Work Order ID 110321

Item Name: Floor Provisions

DART SERVICE INSTRUCTION

TO AMEND INSTALLATION INSTRUCTIONS IIN-D350-689 REV. B AND INSTRUCTIONS FOR CONTINUED AIRWORTHINESS ICA-D350-689 REV. 1

FIGURE 1: UPDATES TO CROSS SECTIONS F-F AND M-M

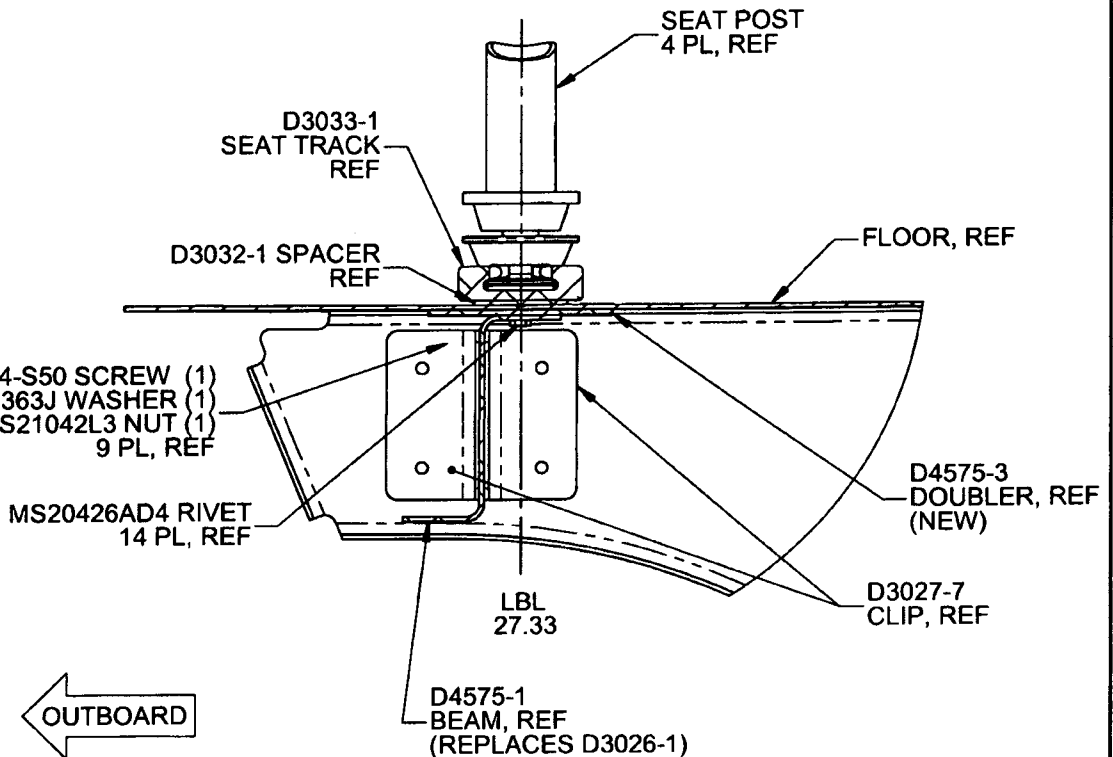
If there is an existing stringer at LBL 27.33, it will need to be removed from that location. Locate D4575-1 Beam, D4575-3 Doubler, and D3032-1 Spacer as shown in Figure 1 of this Service Instruction. Transfer drill existing holes from the aircraft floor to the D4575-1 Beam, D4575-3 Doubler, and D3032-1 Spacer. Ensure 1.0" to 1.5" rivet pitch and add additional holes if required. If there is no existing stringer, locate D4575-1 Beam, D4575-3 Doubler, and D3032-1 Spacer as shown in Figure 1 of this Service Instruction and drill Ø0.128" holes on a 1.0" to 1.5" pitch.

Note: Drill a Ø1.00" (Ø25.4 mm) hole in the D4575-1 Beam to clear extension tube of collective and cutout as required for clearance of collective opening and fwd bulkhead as shown in Figure 3 of this Service Instruction.

If there is an existing stringer at LBL 27.33, it will need to be removed from that location. Locate D3026-1 Channel as shown in Figure 4 and transfer existing holes from the aircraft floor to the D3026-1 Channel & D3032-1 Spacer. Ensure 1.0" to 1.5" rivet pitch and add additional holes if required. If there is no existing stringer, locate D3026-1 Channel & D3032-1 Spacer as shown in Figure 4 and drill Ø0.128" holes on a 1.0" to 1.5" pitch.

If there is an existing stringer at LBL 27.33, it will need to be removed from that location. Locate D4575-1 Beam and D4575-3 Doubler as shown in Figure 2 of this Service Instruction. Transfer drill existing holes from the aircraft floor to the D4575-1 Beam and D4575-3 Doubler. Ensure 1.0" to 1.5" rivet pitch and add additional holes if required. If there is no existing stringer, locate D4575-1 Beam and D4575-3 Doubler as shown in Figure 1 of this Service Instruction and drill Ø0.128" holes on a 1.0" to 1.5" pitch.

FIGURE 2: UPDATES TO FIGURE 21 (IIN-D350-689) AND 25-21 (ICA-D350-689)

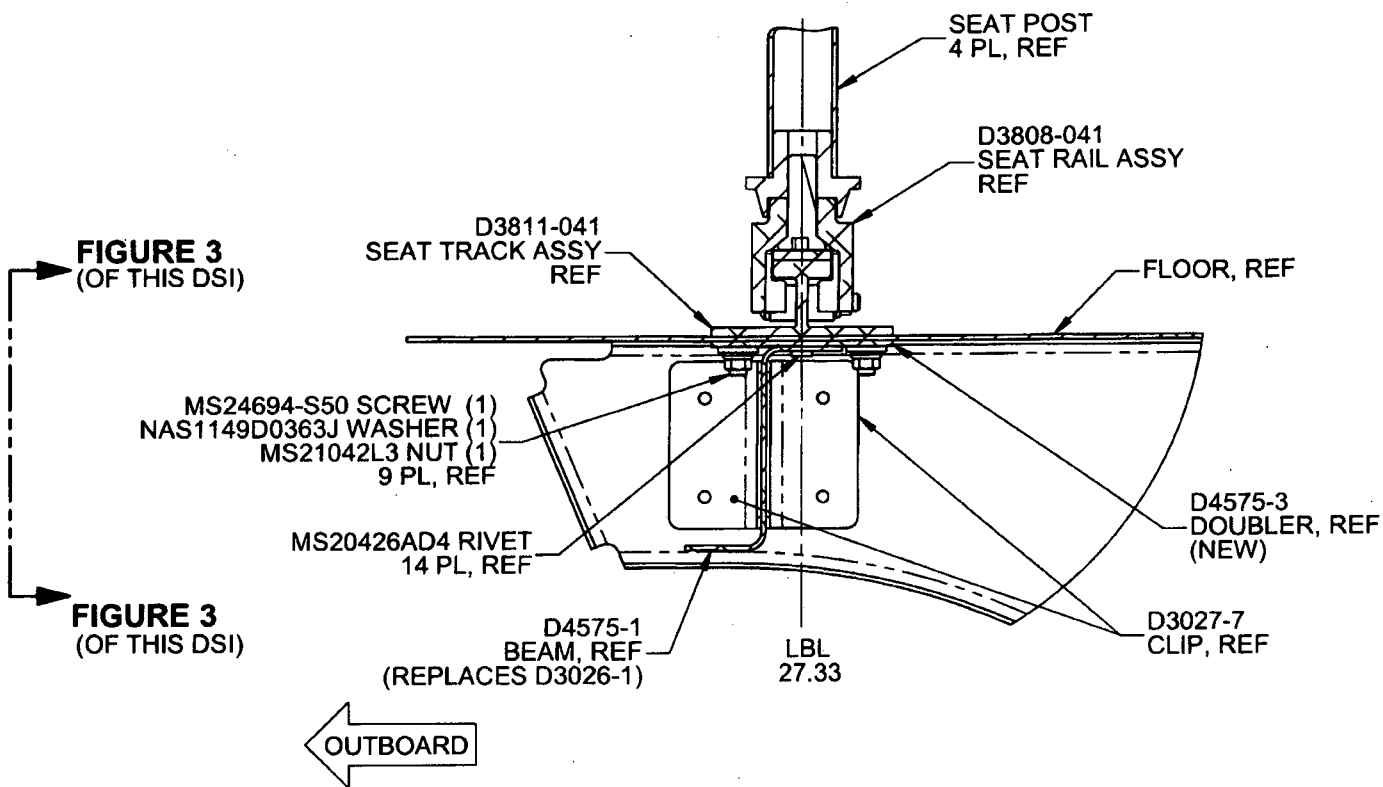
If there is an existing stringer at LBL 27.33, it will need to be removed from that location. Locate D3026-1 Channel as shown in Figure 4 and transfer existing holes from the aircraft floor to the D3026-1 Channel. Ensure 1.0" to 1.5" rivet pitch and add additional holes if required. If there is no existing stringer, locate D3026-1 Channel as shown in Figure 4 and drill Ø0.128" holes on a 1.0" to 1.5" pitch.

FIGURE 3: RELIEFS ON D4575-1/-3
(ONLY D4575-1/-3 SHOWN FOR CLARITY)
VIEW LOOKING INBOARD

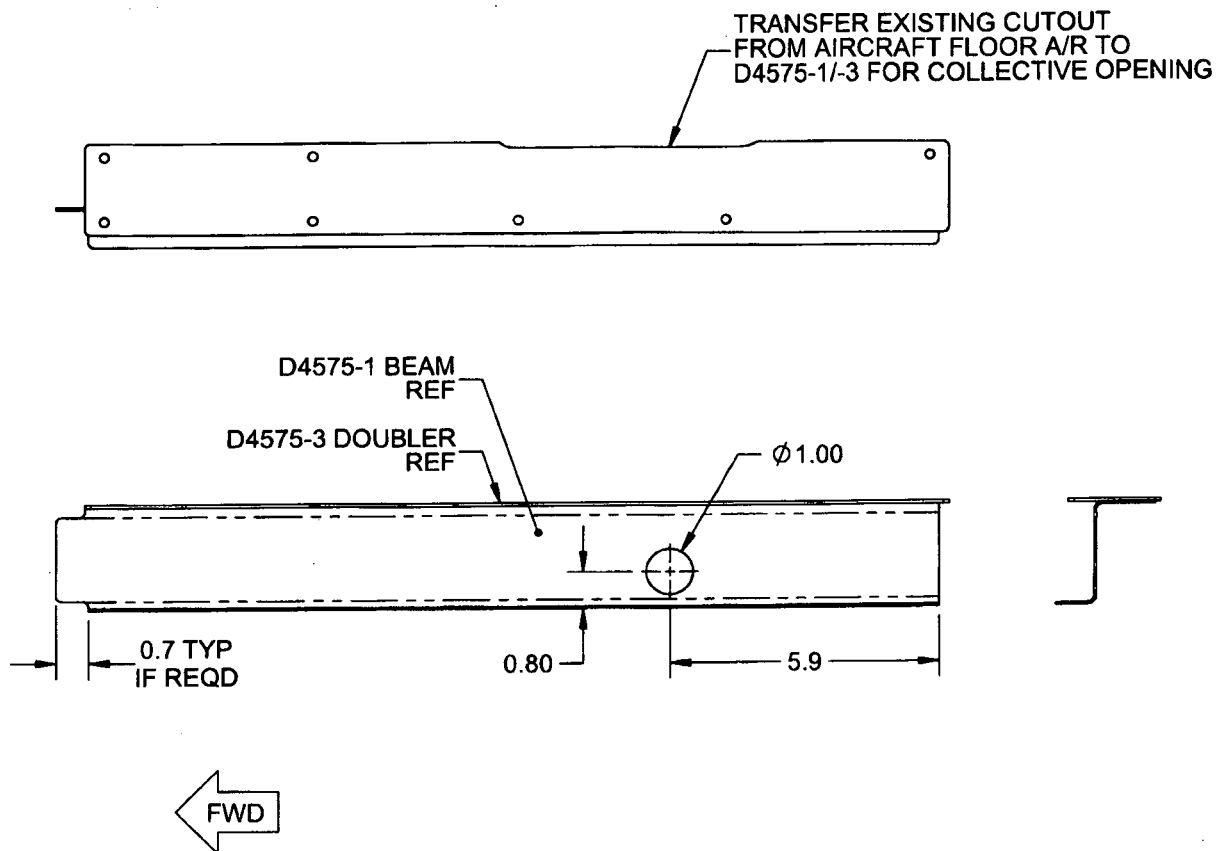
Note: Drill a Ø1.00" (Ø25.4 mm) hole in the D4575-1 Beam to clear extension tube of collective and cutout as required for clearance of collective opening and fwd bulkhead as shown in Figure 3 of this Service Instruction.
